ECE/TRANS/WP.29/GRE/2006/18  
23 January 2006

World Forum for Harmonization of Vehicle Regulations (WP.29)

PROPOSAL FOR DRAFT AMENDMENTS TO REGULATION No. 48

(Installation of lighting and light-signalling devices)

**INDICATION OF THE DOWNWARD INCLINATION OF THE FRONT FOG LAMP  
CUT-OFF REFERRED TO IN PARAGRAPH 6.3.6.1.2. OF THIS REGULATION**

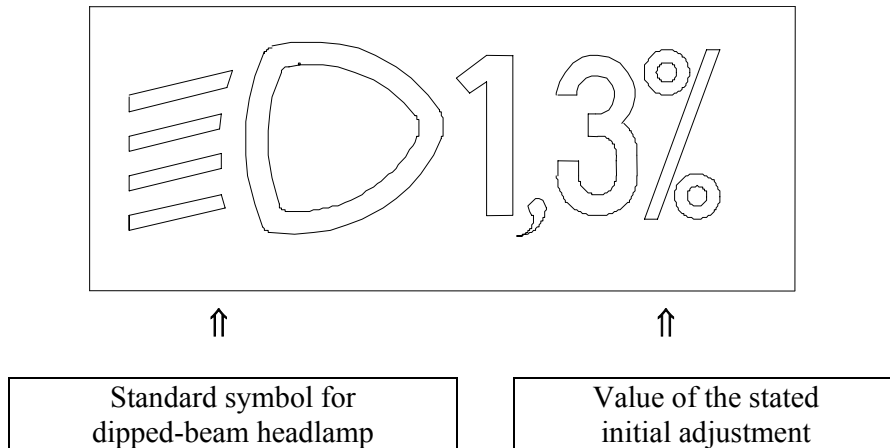
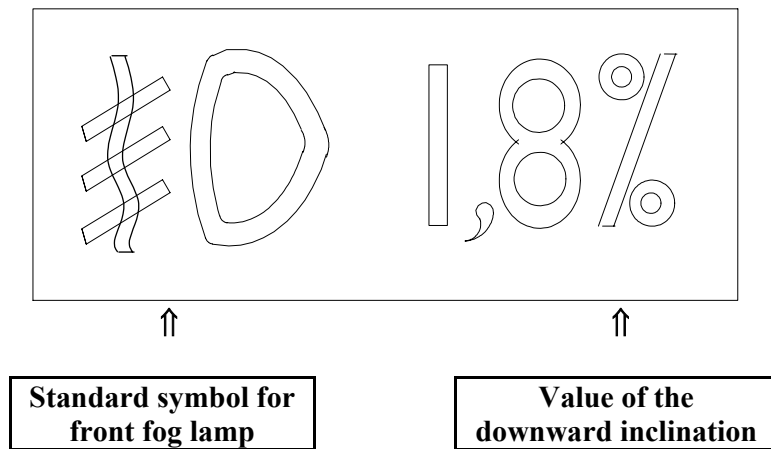
Annex 7, amend to read:

**Example 1**

The size of the symbol and characters is left to the discretion of the manufacturer.

**Example 2**

The size of the symbol and characters is left to the discretion of the manufacturer."
